HISTORIC AND DESIGN REVIEW COMMISSION

February 05, 2025

HDRC CASE NO: 2024-343
ADDRESS: 284 THORAIN BLVD
LEGAL DESCRIPTION: NCB 9009 BLK 5 LOT 2 3, 4 AND E 20.5 FT OF 1
ZONING: O-2, H
CITY COUNCIL DIST.: 1
DISTRICT: Olmos Park Terrace Historic District
APPLICANT: Daniel Alonso Medina/DANVAL MANAGEMENT LLC
OWNER: Daniel Alonso Medina/DANVAL MANAGEMENT LLC
TYPE OF WORK: Façade modifications, window replacement, construction of a 1,143-square-foot rear addition, site work
APPLICATION RECEIVED: January 17, 2025
60-DAY REVIEW: March 18, 2025
CASE MANAGER: Rachel Rettaliata

The applicant is requesting conceptual approval to:

NAME
SITE PLAN

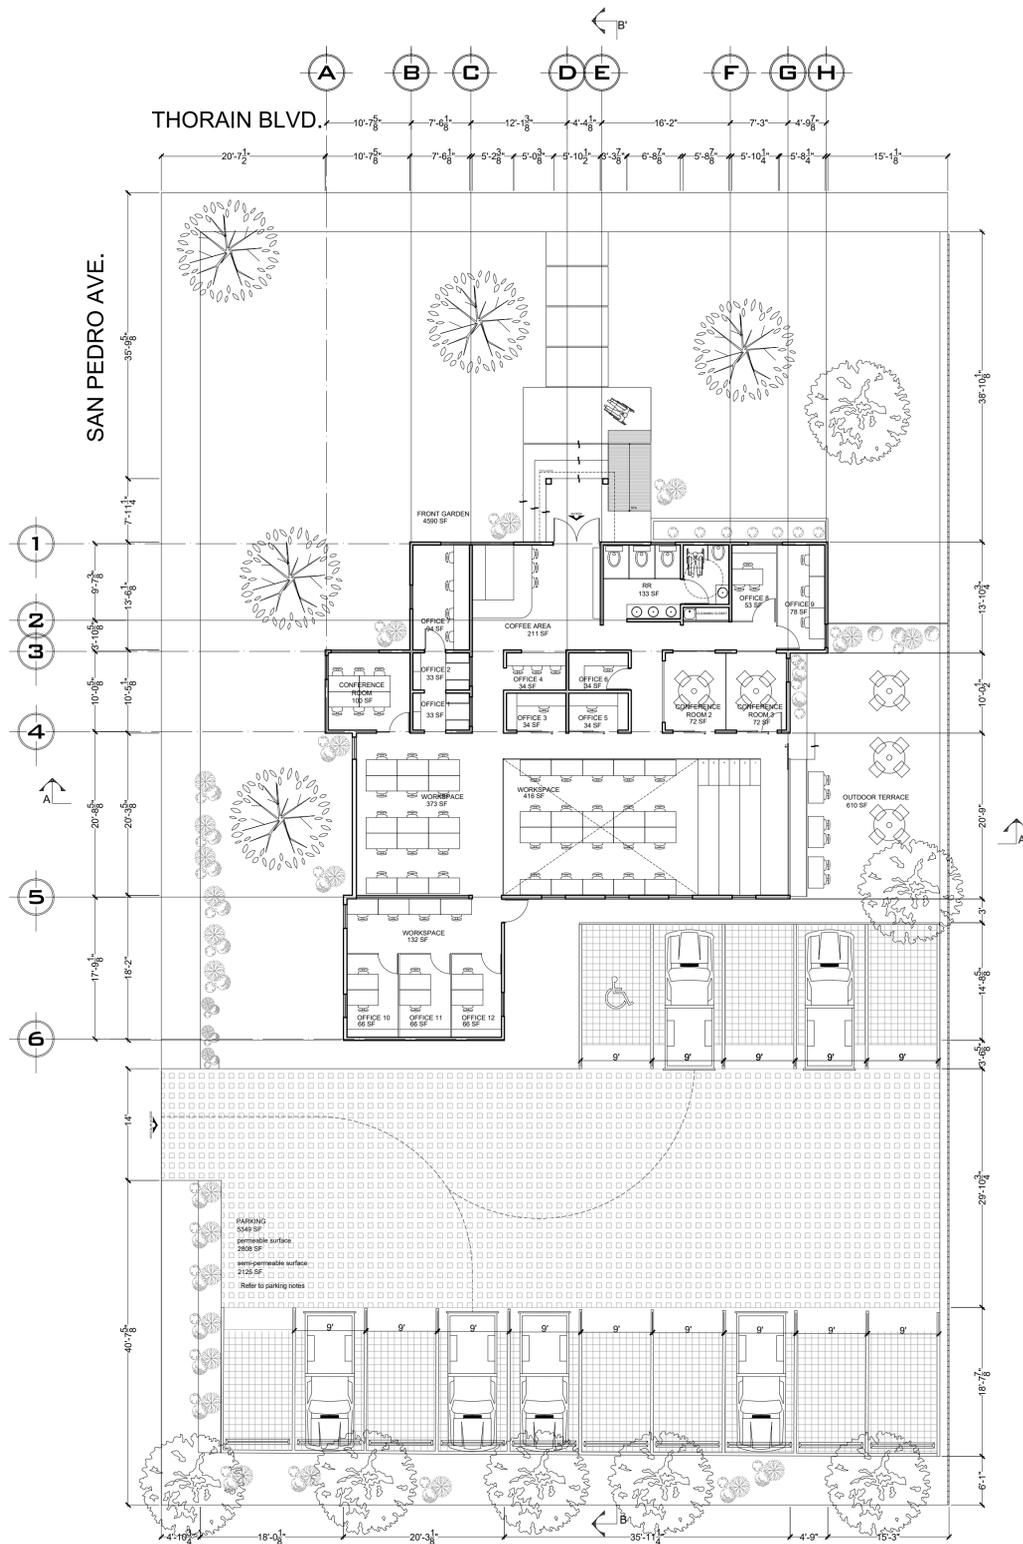
- p. LANDSCAPING AND SITE WORK – The applicant has submitted a site plan showing the intention to retain the front lawn, remove the front driveway and install grass, retain existing trees and plant addition trees, install a seating area on the east side of the property, install motorcycle and bicycle racks along San Pedro, and install front walkway pavers from San Pedro and Thorain to the front entrance. Guideline 5.A.i. for Site Elements states that historic sidewalk and walkway paving materials—often brick or concrete—should be retained in place. Staff recommends that the applicant retains the existing front walkway footprint, dimensions, material, and configuration and does not introduce an additional front walkway to the site.

- i. That the applicant reduces the amount of paving by introducing permeable surfacing to comply with the Guidelines. The applicant is required to submit an updated site plan and material specifications to staff for review prior to returning to the HDRC for final approval.

- i. That the applicant retains the existing front walkway footprint, dimensions, material, and configuration and does not install a secondary walkway to the site. The applicant is required to submit an updated dimensioned site plan with material specifications and a final landscaping plan to staff for review prior to returning to the HDRC for final approval.

A-02

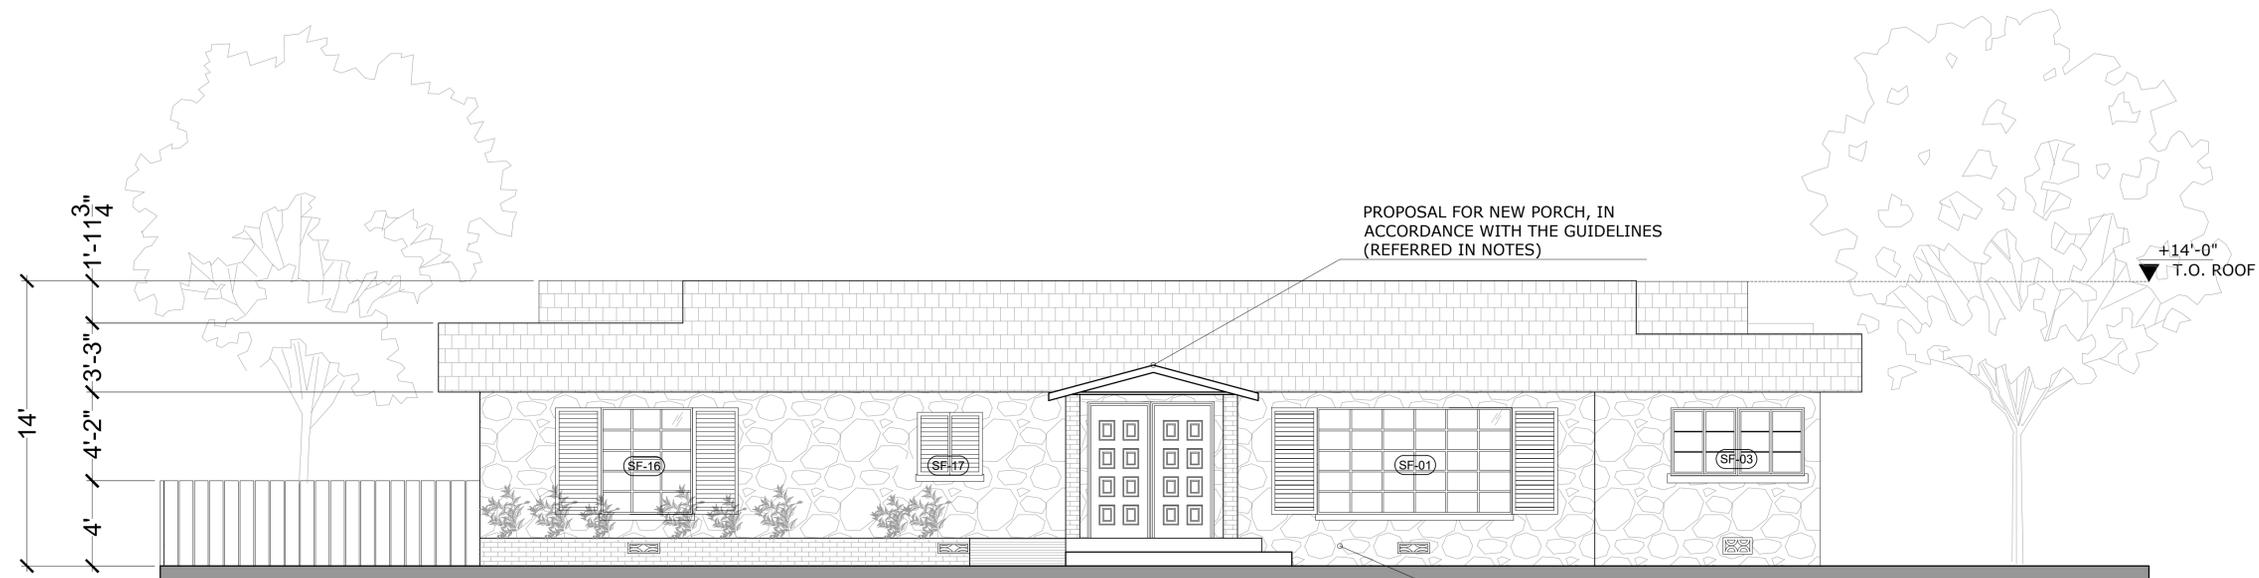
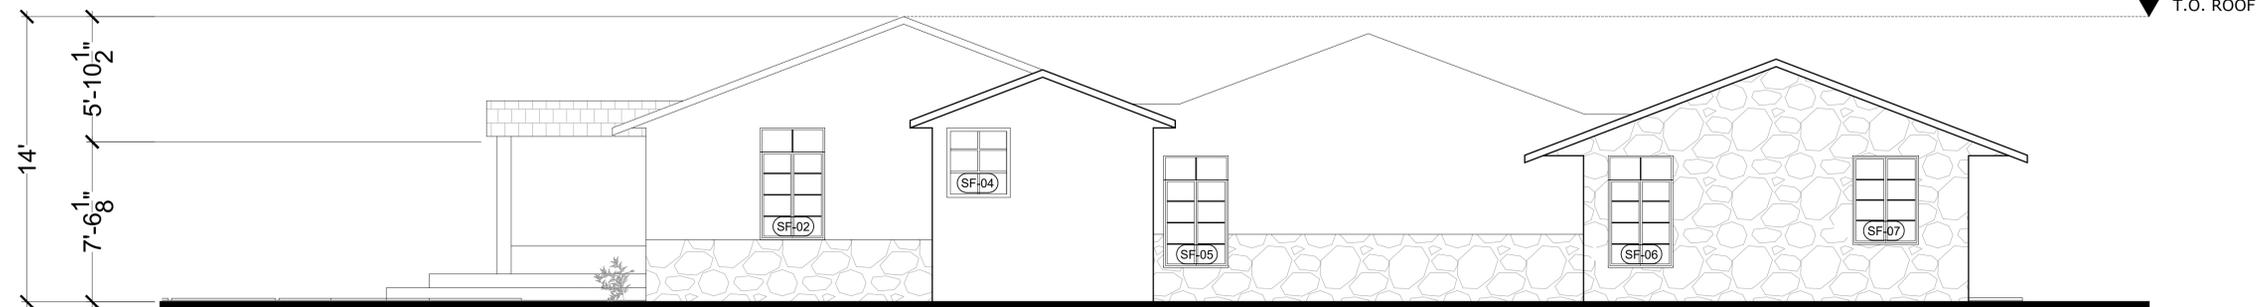
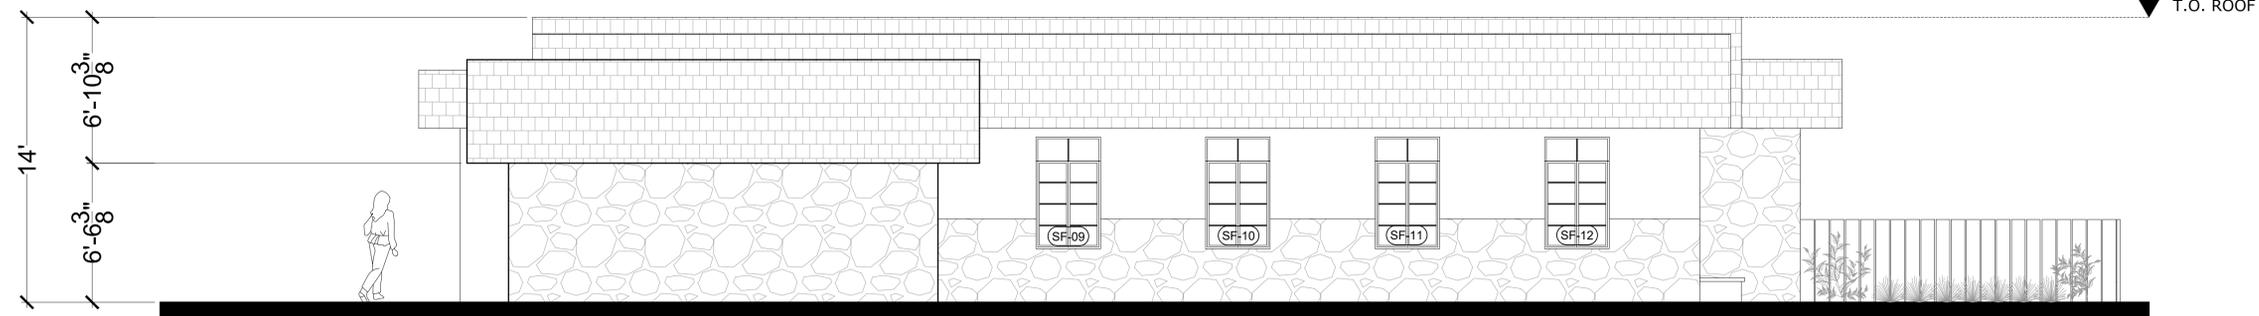
- c. FRONT PORCH MODIFICATIONS – The applicant has proposed to modify the front porch entry to feature an extended front gable composition shingle porch roof on brick columns. Additionally, the applicant has proposed to modify the front door opening to feature a double door entry with two solid doors matching the style of the existing wood door. The front porch will retain the look of the existing front step entry; however, it will be replaced to feature wider steps. According to Guideline 6.A.i for Exterior Maintenance and Alterations, existing window and door openings should be preserved. Applicants should avoid enlarging or diminishing to fit stock sizes or air conditioning units, filling in historic door or window openings, or creating new primary entrances or window openings on the primary façade or where visible from the public right-of-way. Additionally, Guideline 7.B.iv for Exterior Maintenance and Alterations states that replacement elements, such as stairs, should be designed to be simple so as to not distract from the historic character of the building. Do not add new elements and details that create a false historic appearance. Staff finds that the front door opening modification and the front porch column and awning installation to be inconsistent with the Guidelines.

- d. CLADDING MODIFICATIONS – The applicant has proposed to modify the limestone cladding on the east and west elevations to feature stucco on the upper portion of the side elevation and to retain the limestone as a wainscoting-like accent material. Guideline 1.B.i for Exterior Maintenance and Alterations states that applicants should avoid removing materials that are in good condition or that can be repaired in place. Replacement materials should be in-kind. Replacement materials should be compatible with the original in terms of composition, texture, application technique, color, and detail. Staff finds the proposal to modify the cladding on the east and west elevation of the existing structure to be inconsistent with the Guidelines. Staff finds that the existing limestone cladding should be retained and repaired.

Item 1, staff does not recommend approval of the front porch modifications based on finding c. Staff recommends that the applicant retain the front door opening and the front porch entry as existing.

Item 2, staff does not recommend approval of the proposed cladding modifications based on finding d. Staff recommends that the existing limestone cladding is retained and repaired.

NAME
WINDOW PROPOSAL

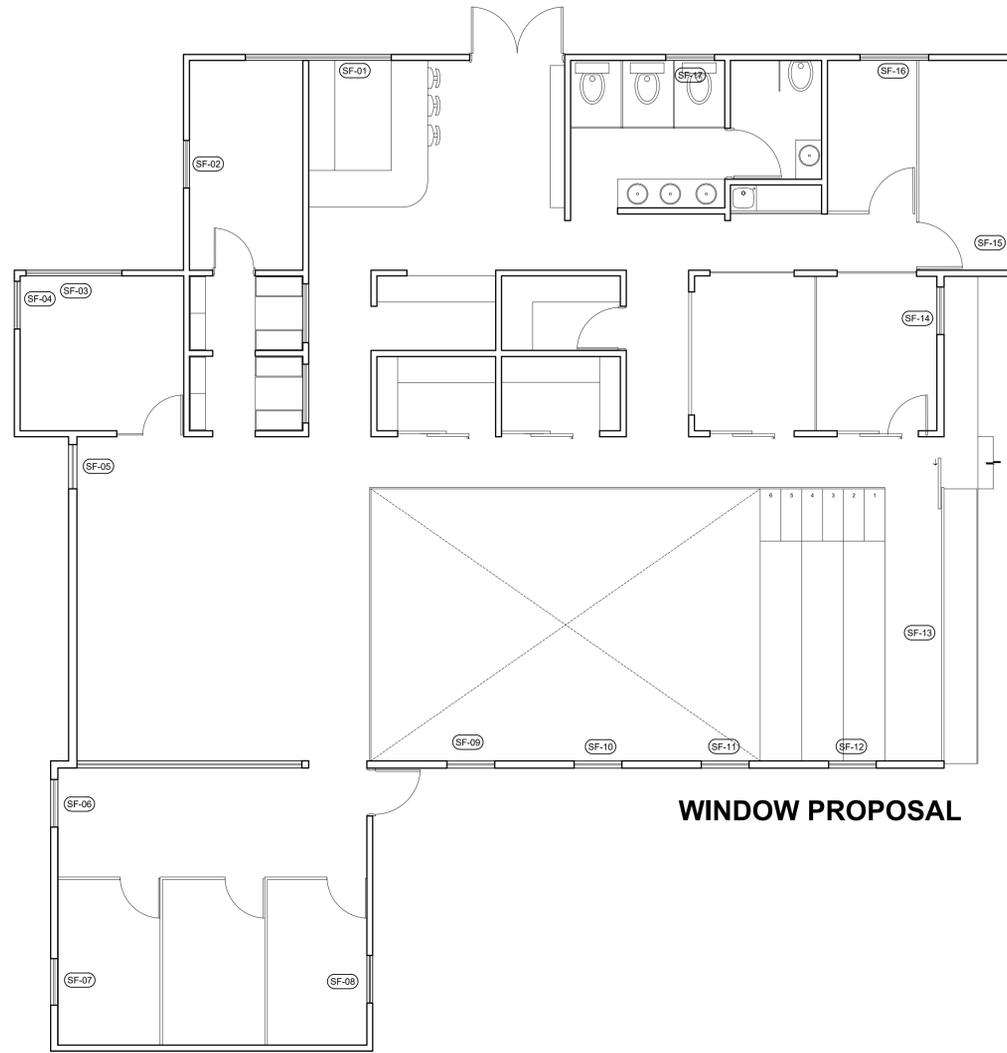
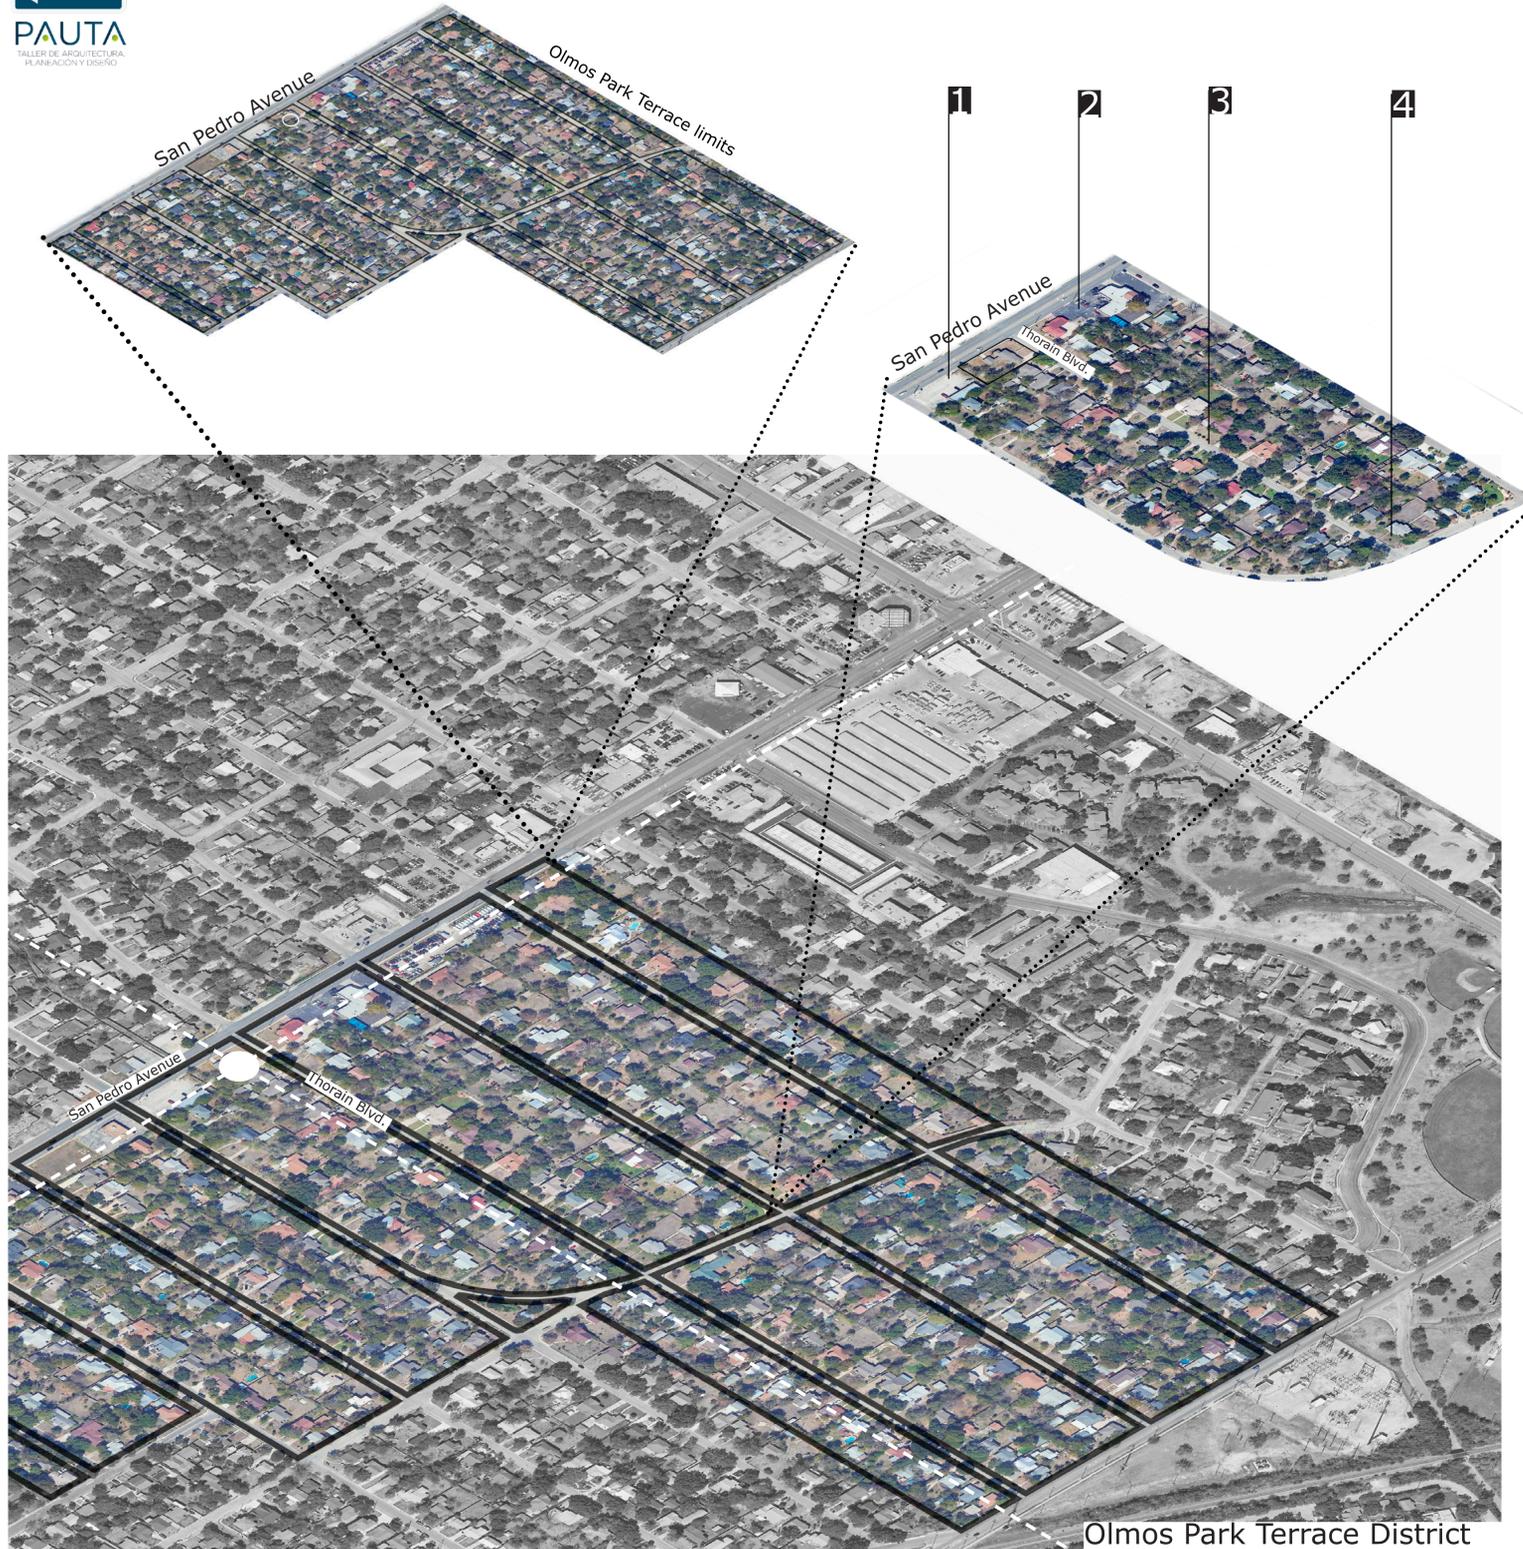
- e. WINDOW REPLACEMENT – The applicant has proposed to replace the original steel casement windows with new steel casement windows to match the existing lite configuration and profile. Guideline 6.B.iv. for Exterior Maintenance and Alterations states that replacement windows should be installed to match the historic or existing windows in terms of size, type, configuration, material, form, appearance, and detail when original windows are deteriorated beyond repair. Staff conducted a site visit on September 26, 2024, to inspect the

condition of the existing windows. The windows have not had regular maintenance for several years, which has rendered most of the windows inoperable and prone to water infiltration furthering their worsening condition. Some windows feature poor repairs. All windows will require extensive repairs not limited to putty, caulking, paint, and rust removal in addition to hardware and glazing replacement. Staff finds that the replacement of the existing steel casement windows with a replacement product that matches the size, type, configuration, material, form, appearance, and detail to be appropriate.

- i. That the applicant submits material specifications for the proposed replacement window product showing that the product matches the existing windows in size, type, configuration, material, form, appearance, and detail to staff for review prior to returning to the HDRC for final approval.
